NORTHEAST UTILITIES

November 19, 1987

Millstone Nuclear Power Station, Unit No. 3
Proposed Revision to Technical Specification
Containment Penetration Conductor Overcurrent Protective Devices

Figure 1

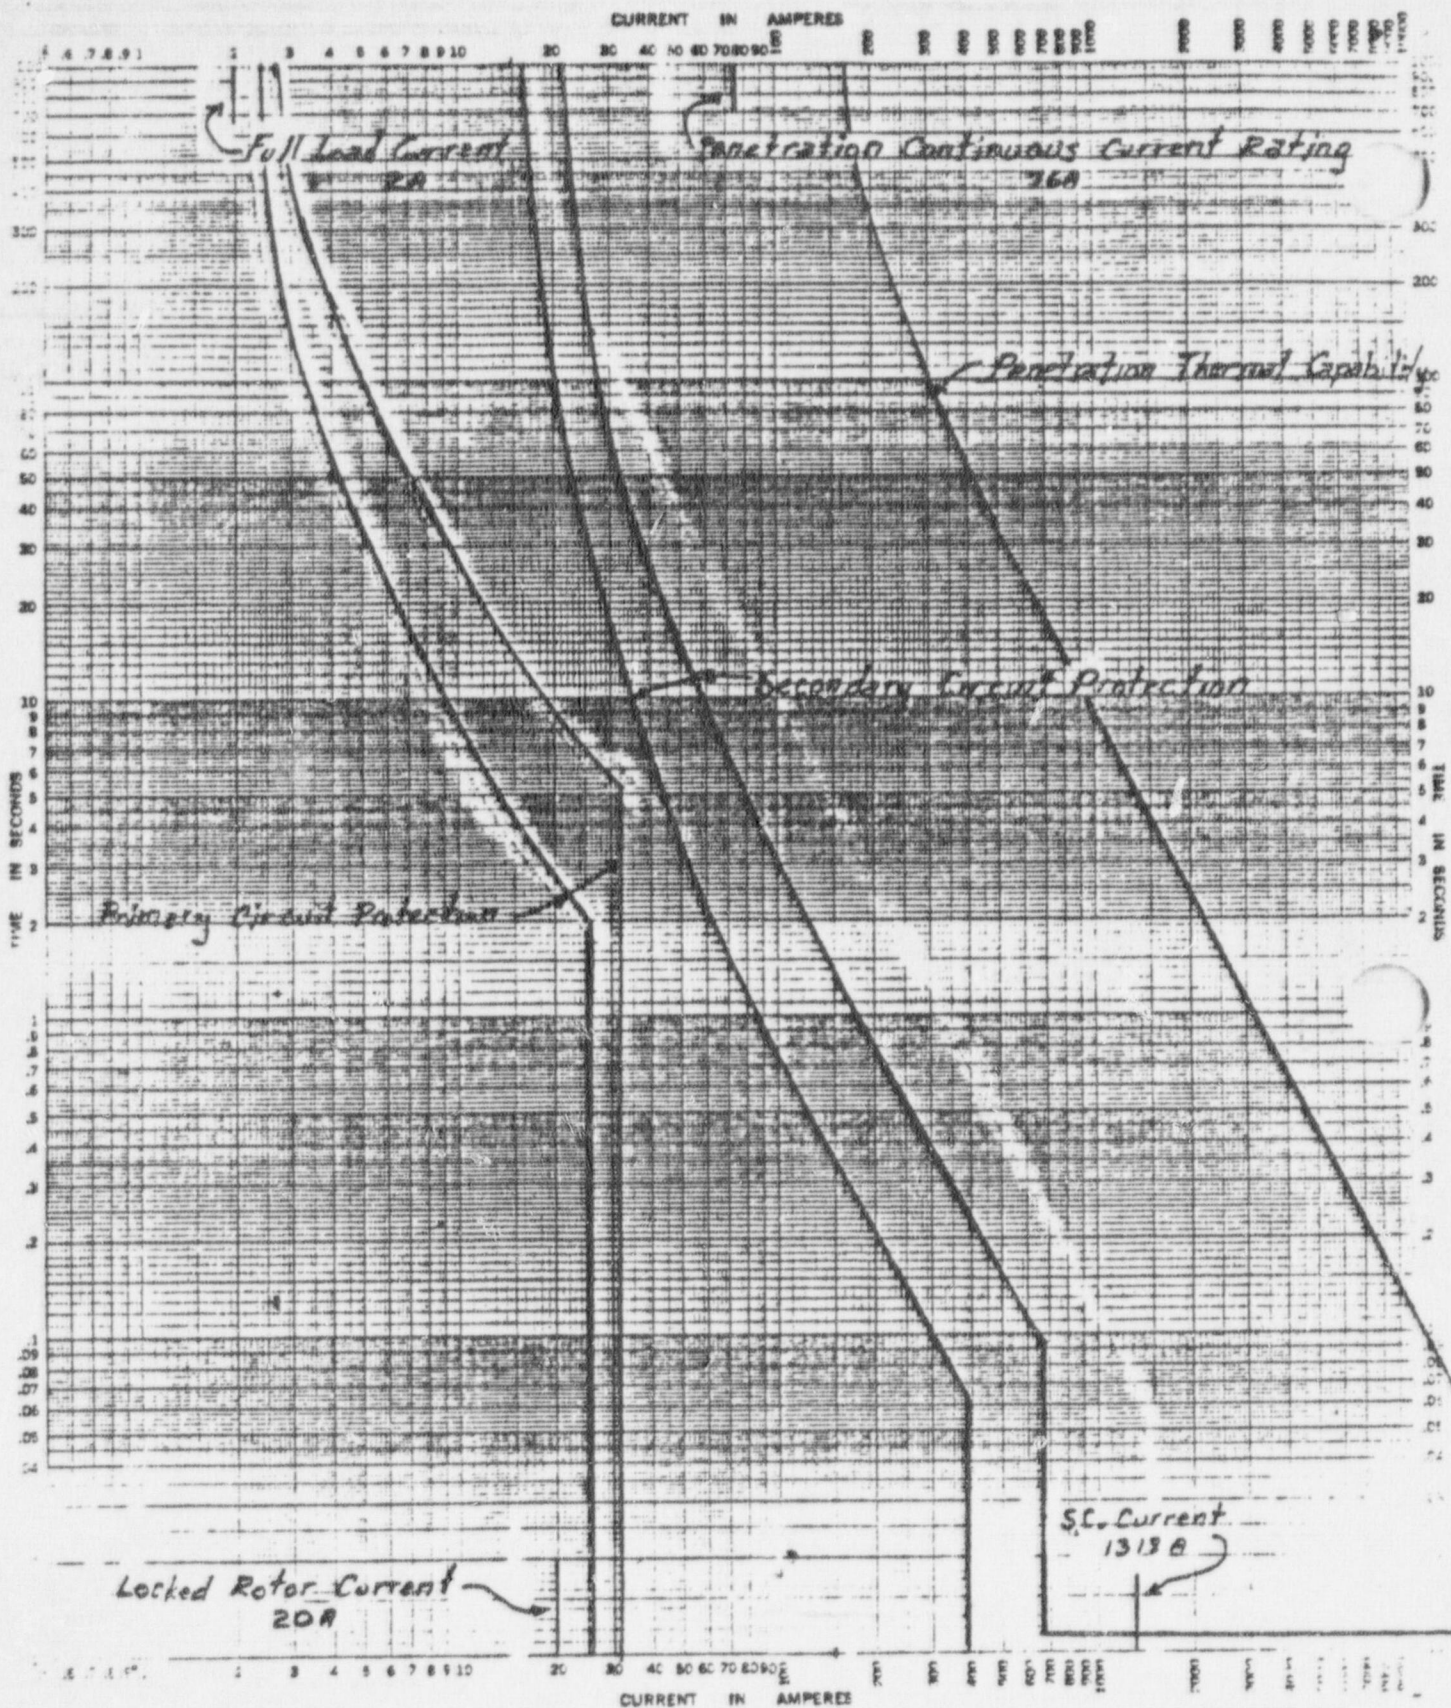
<u>Device</u>	<u>Time Delay Test Value (300% of Device Rating)</u>	<u>Instant. Test Value Range (-25% to +40%)</u>
Primary Device	$3 \times 2.19A = \underline{6.57A}$	Low end = $29 - (0.25)(29) = \underline{21.8A}$ High end = $29 + (.40)(29) = \underline{40.6A}$
Secondary Device	$3 \times 15A = \underline{45A}$	Low end = $400 - (.25)400 = \underline{300A}$ High end = $700 + (.40)700 = \underline{980A}$

Instantaneous Thermal Limit of Penetration - Greater than 10,000A

See attached curve (Figure 1) for graphical illustration.
